Record of Decision
Niagara Mohawk
Broadway – Schenectady MGP Site
Schenectady(C), Schenectady County, New York
Site Number 4-47-026

March 2008

DECLARATION STATEMENT - RECORD OF DECISION

This responsiveness summary responds to all questions and comments raised during the public comment period. The following are the comments received, with the Department's responses:

**Figure 9 - Alternative 4
Containment Barrier
With Excavation
Schenectady, Broadway MGP Site
4-47-026**

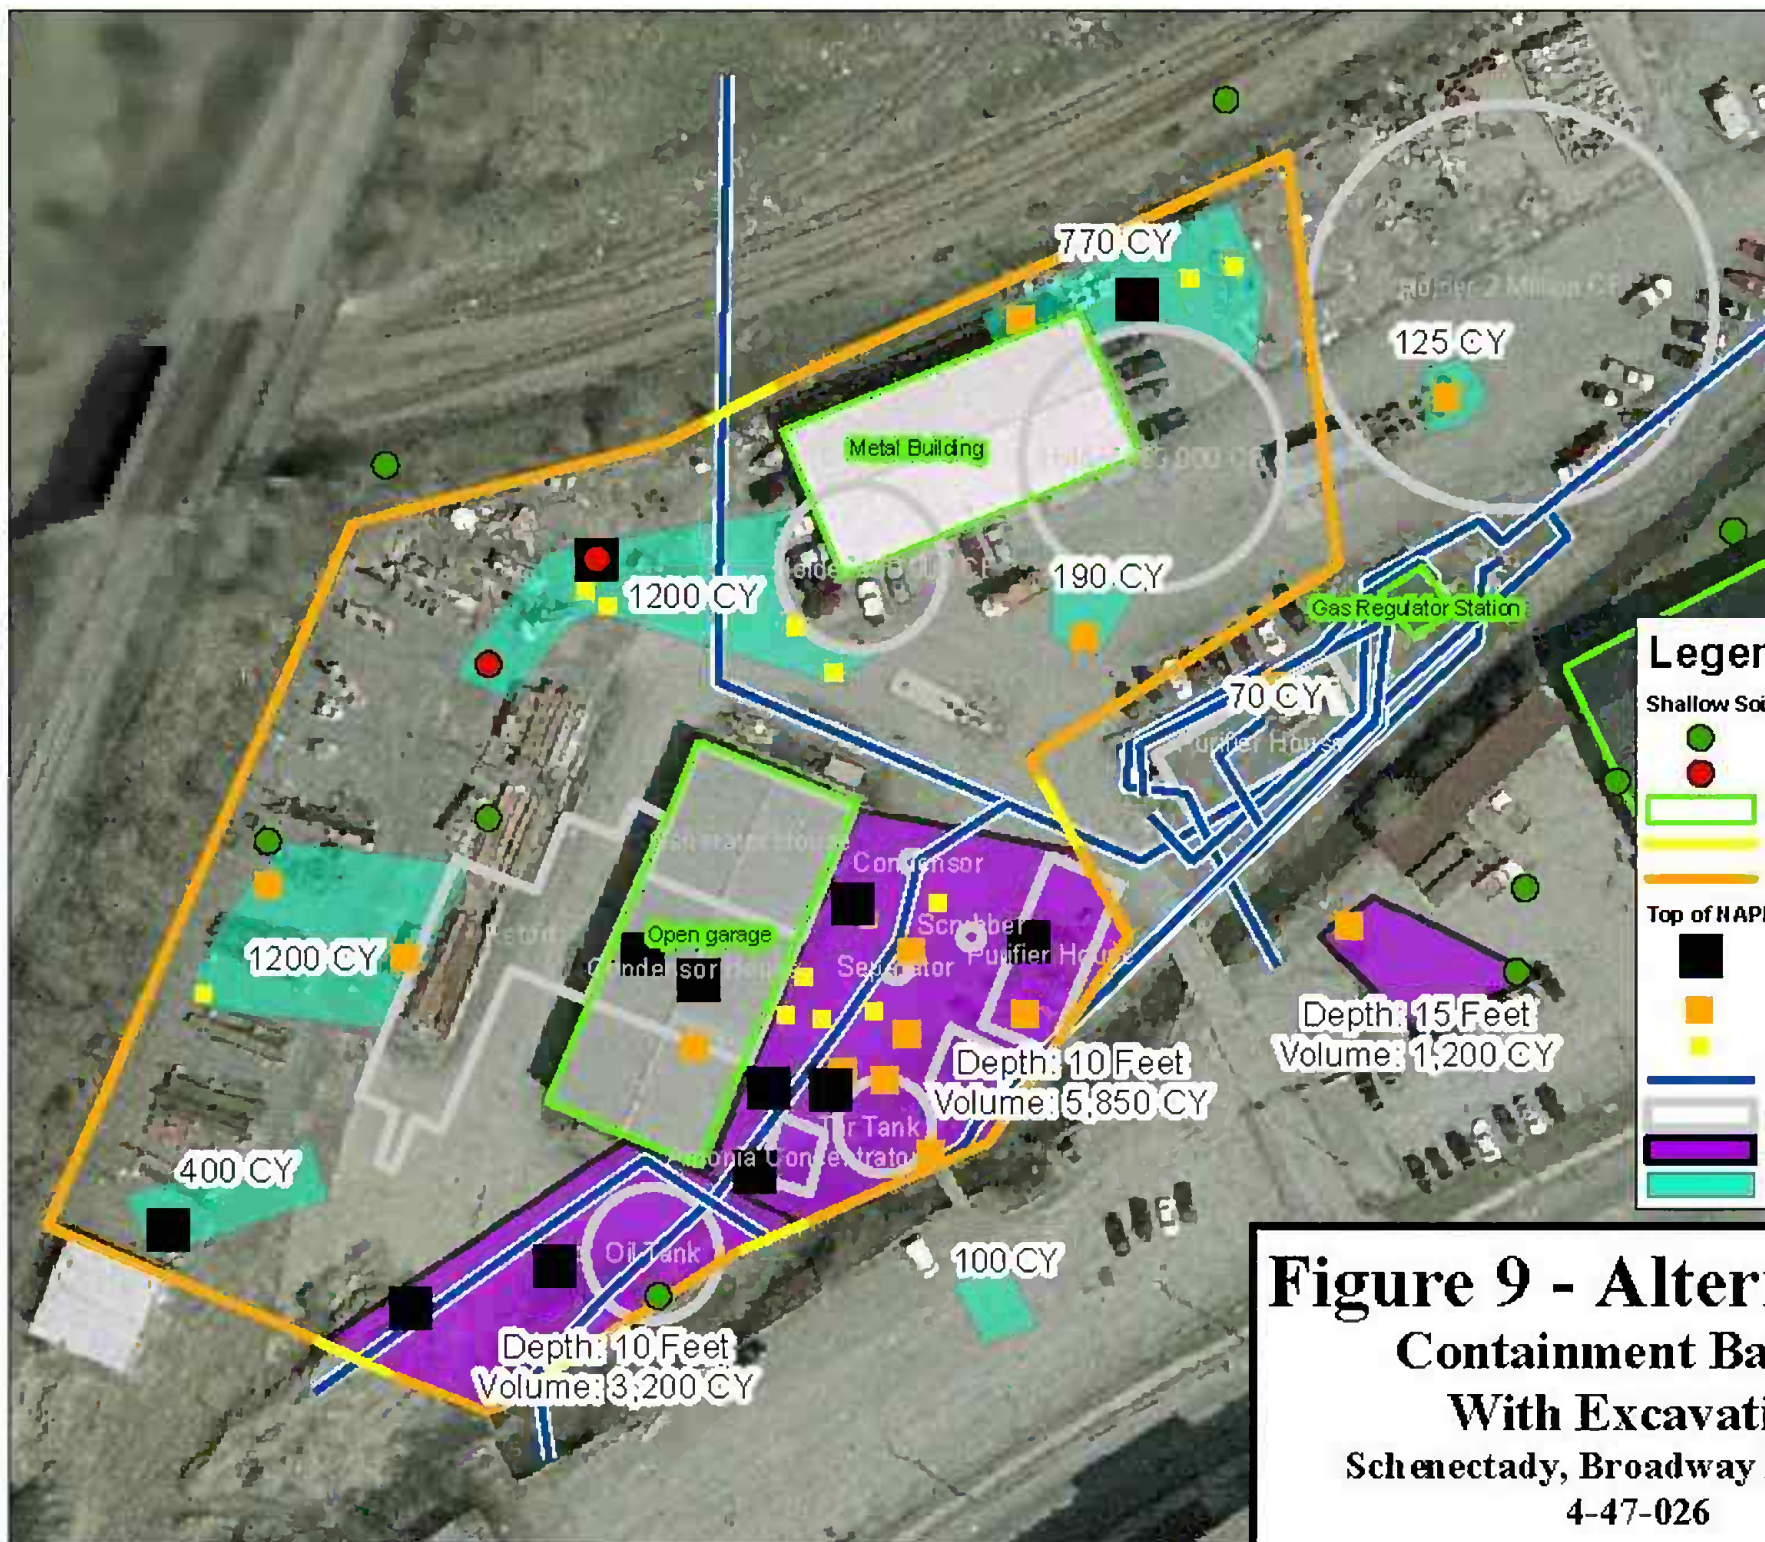
COMMENT 5: The excavation proposed below the water table in item 3 of the selected alternative is not justified because contact with that material would not be likely to occur.

COMMENT 6: Excavation of material near the gas regulator station (GRS) could require relocation of the GRS, which would not be cost effective and which could represent significant short term impacts and risks.

COMMENT 7: Working around active natural gas mains is a significant short term risk. Relocating them would involve cost and short term risks and impacts.

COMMENT 8: The excavation east of the open garage (between the garage and the Creek) could cause the temporary relocation and/or disruption of portions of an active service center.

COMMENT 10: The Site Management Plan and the asphaltic cap would adequately protect the on-site workers from exposure to shallow contamination without the extra expense of removing this material.

RESPONSE 5: Physical removal of source materials is preferred wherever practicable, even in cases where containment measures are a component of the remedy. Although removal below the water table is more complicated and costly, it is justified when it represents a source area or if is in a location where contact is more likely (the site will remain an active National Grid service center). Structures are to be excavated to eliminate these sources of contamination. Deeper excavation in the vicinity of the Schermerhorn Creek is justified since construction and maintenance of the culvert (or barrier if a culvert is not constructed) would make future contact more likely.

RESPONSE 6: It is not the intent of the remedy to require relocation of the GRS. During our meeting with National Grid site workers, eliminating shallow contamination in this area was identified by workers as being a particular concern due to the potential for direct contact exposures. Excavation in this area which can be accomplished by hand or by vacuum truck can be completed without relocating the GRS.

RESPONSE 7: Some amount of work around active mains is required, even under National Grid's preferred (containment only) remedy. The construction of the containment barrier will involve work in the immediate vicinity of these same gas lines. Minimizing or eliminating utilities crossing that barrier would be preferred.

RESPONSE 8: The Department believes the ROD allows flexibility to accommodate operations at the service center. Completing this work in smaller pieces would make it less disruptive, but could also take longer and make the project more expensive. There are numerous aspects of the implementation of this remedy which will be considered and addressed during the remedial design, including the one raised by the comment.

RESPONSE 10: Institutional and engineering controls of this sort provide some protection, but removal is a more reliable protection. The preference to remove source material rather than manage it with controls is defined by statute.
